RE: Dispute Issues for the Groundwater Operable Unit, Weldon Spring Site Remedial Action Project, Weldon Spring, Missouri

DETAILED COMMENTS
Weldon Spring Site Remedial Action Project (WSSRAP)
Groundwater Operable Unit (GWOU)

Figure 4: Pilot Pump Test Location

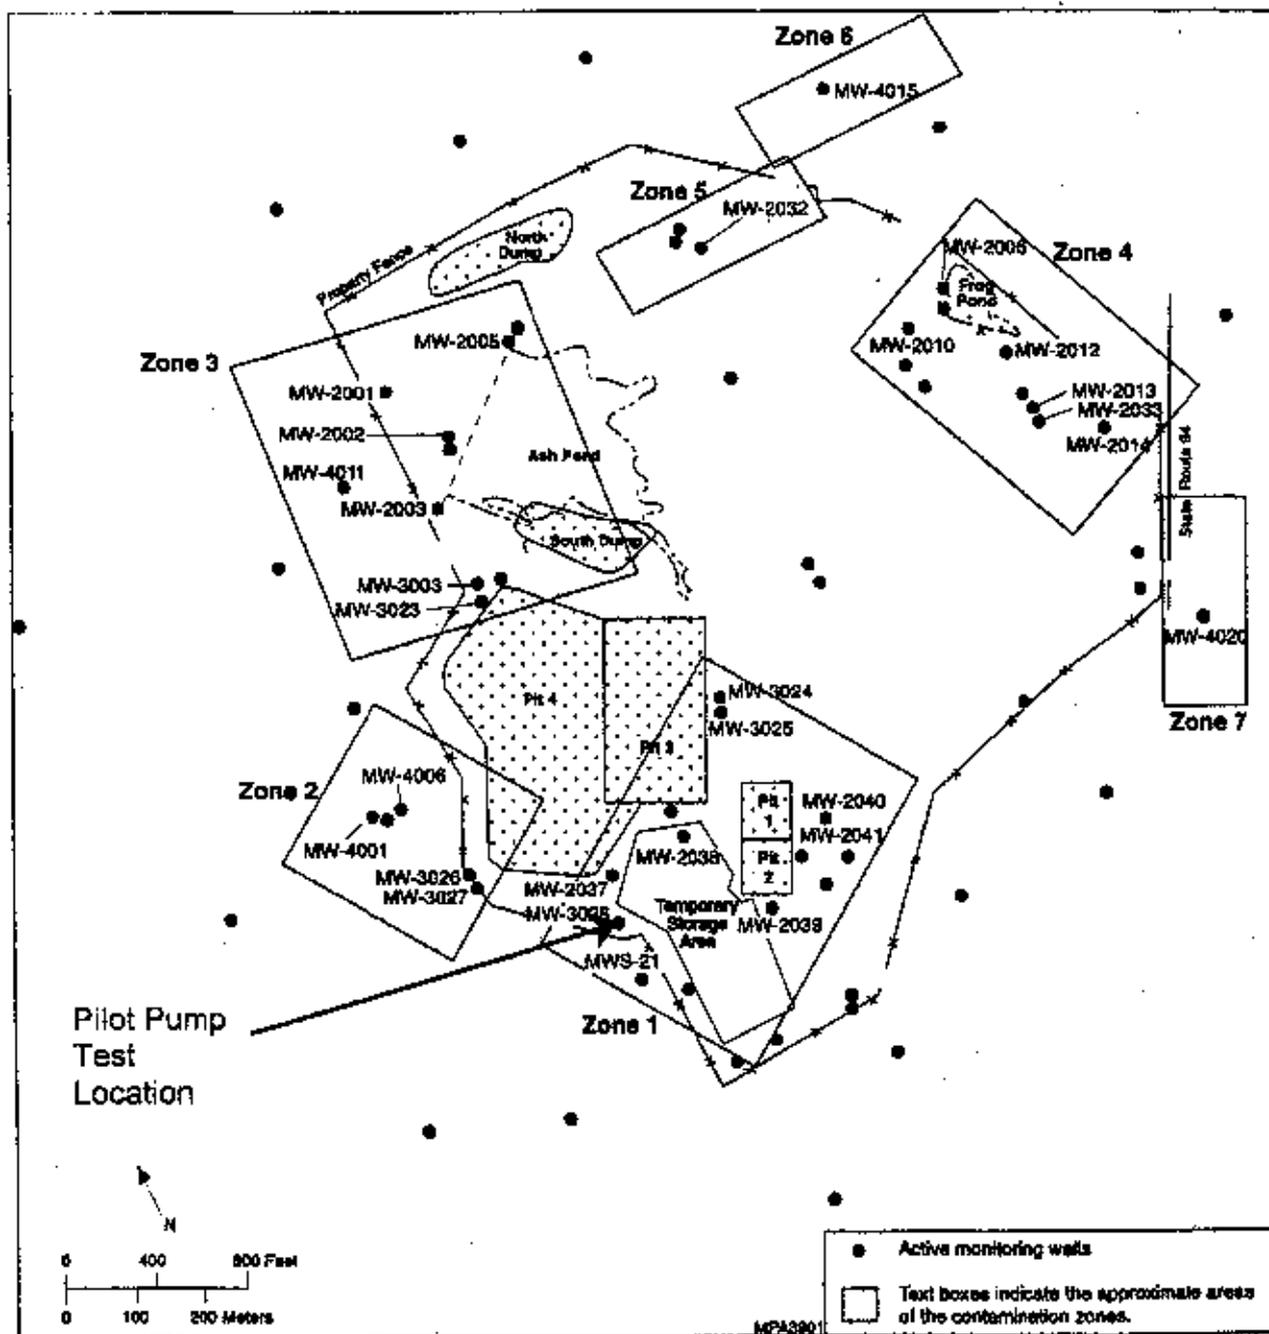
DOE originally developed the pump and treat alternatives (#4 and #7) in the FS that included the possibility of reinjecting treated groundwater back into the aquifer. This option (reinjection) was not developed further due to the large number of injection wells required and the low hydraulic conductivity thought to exist throughout the site (page 3-12, Ref. 2). Since the release of this FS, DOE has performed a field test to collect hydrogeological data in the area of Contaminant Zone #1, (Figure 4). This field test, a Pilot Pump Test was completed in August 1998.

The new data from the Pilot Pump Test was compiled in a completion report (Completion Report for the Pilot Pump Test) which concluded that the transmissivity of Zone #1 was much greater than expected and that sustainable extraction rate exceeded previous expectations. Transmissivity is defined as the rate a fluid is transmitted through a unit width of porous media while under the influence of a unit hydraulic gradient. In the area of MW-3028 the transmissivity of the aquifer was over 700 times more than previously measured prior to the Pilot Pumping Test (p. 51, Ref 3). Table 1 shows the measured transmissivity for the area of concern.

Figure 5: Remediation Times for Contaminant Zone #1 Based on 10 gpm Extraction Rate and a Range of Pore Volume Removal

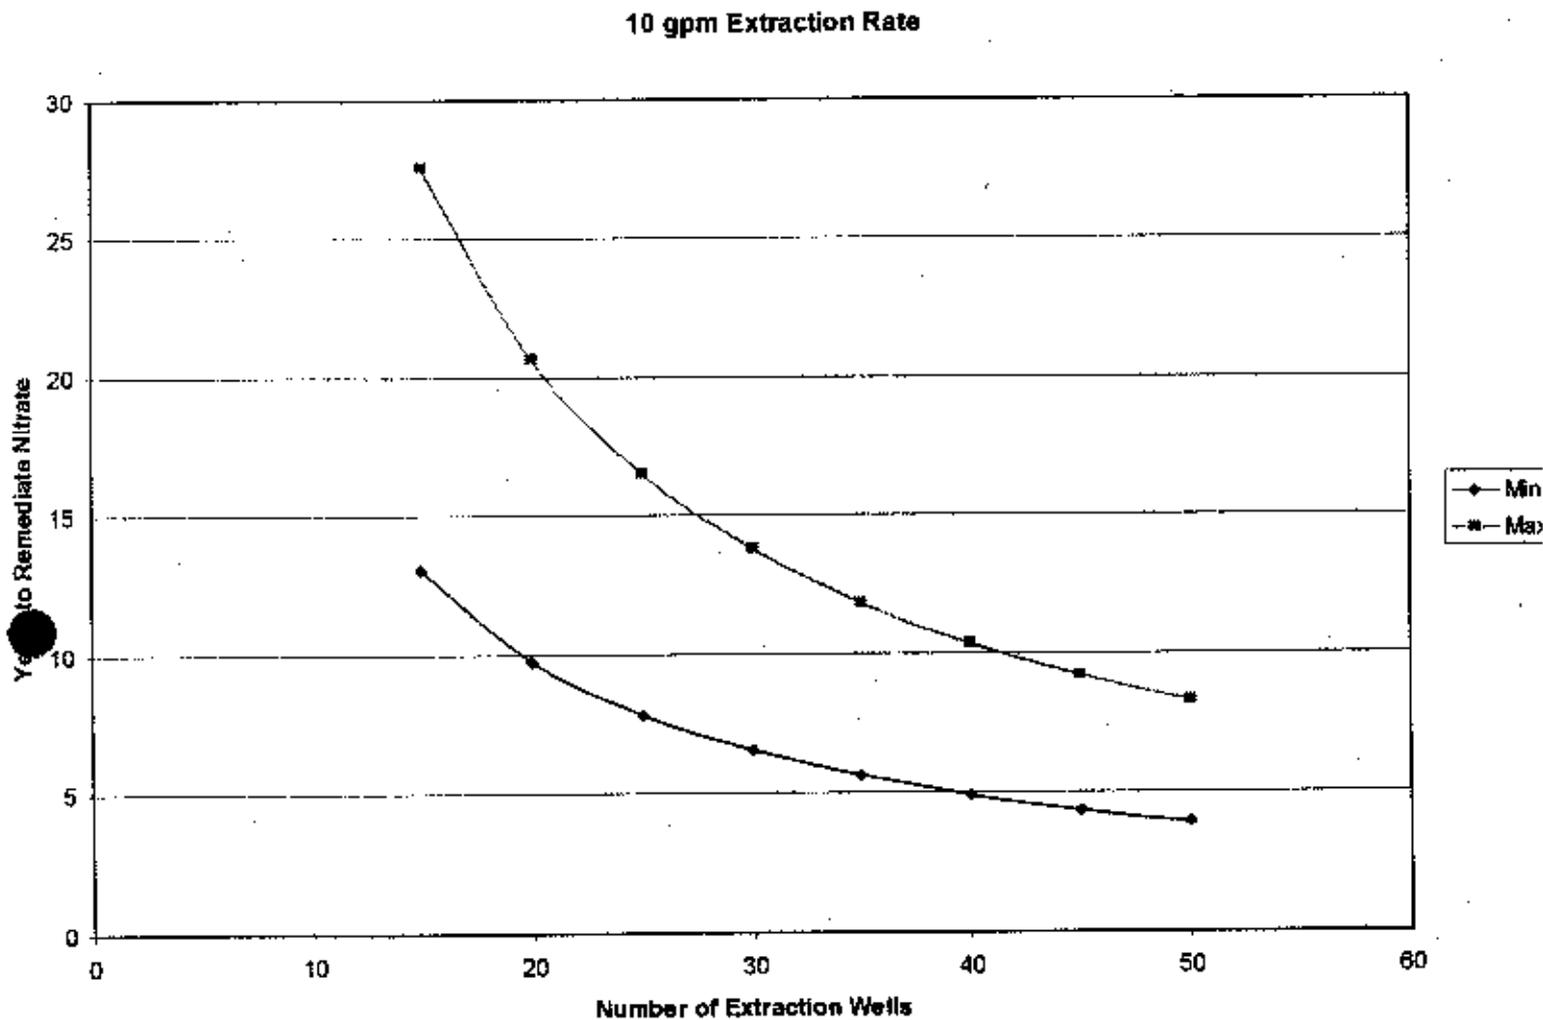
A) The minimal number of wells needed to contain the zone of contamination was used to calculate remediation times. This would equate to a conservatively long remediation time. The optimal number of wells to remediate a zone of contamination would provide for remediation of certain zones in a reasonable time period and a period of time that can be planned for (Figure 5).
